# Backfeed in a 4-pair context v102

**Lennart Yseboodt**

Philips Lighting – Research

April 4, 2018

## 4-pair backfeed

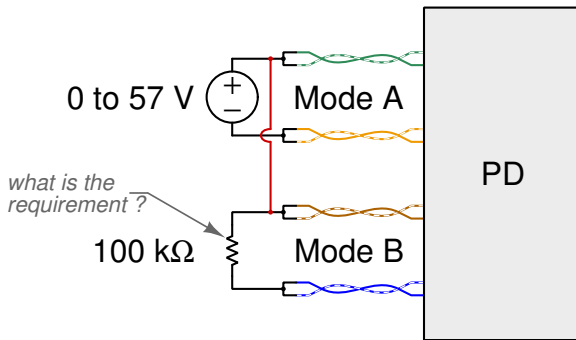
A 4-pair capable PSE typically ties the positive lines together at the PSE end. Even in “2-pair” mode, there are two pairs connected to the positive  $V_{PSE}$ . **Does the backfeed requirement still apply? Should it?**

The current text is ambiguous as to whether the condition of two positive pairs is one where backfeeding is limited to  $V_{bfd}$ . The intent of the text did not anticipate more than 2 pairs being powered (as this is old text), but it does not clearly exclude it, since connecting one pair of a Mode to a supply rail does not constitute “applying a voltage”.

We must choose to either include or exclude this configuration from the backfeed spec and change the requirement accordingly.

When any voltage in the range of 0 V to  $V_{\text{Port\_PD-2P max}}$  is applied ~~across the PI at either polarity specified on the conductors of either Mode A or Mode B according to Table 145-20~~ per any of the valid 2-pair configurations with one and only one pair connected to positive  $V_{\text{PSE}}$  listed in Table 145-20, the voltage measured ~~across the PI for~~ on the other Mode with ~~a any 100 k $\Omega$  load resistor~~ resistance of 0 to 100 k $\Omega$  connected across that other Mode shall not exceed  $V_{\text{bfd}}$  as defined in Table 145-29.

Without strong indication of technical issues caused by 3-pair backfeeding, there is no reason to impose a hard to meet requirement on the PD. As such, we should adopt the “exclusion” baseline on slide 9.
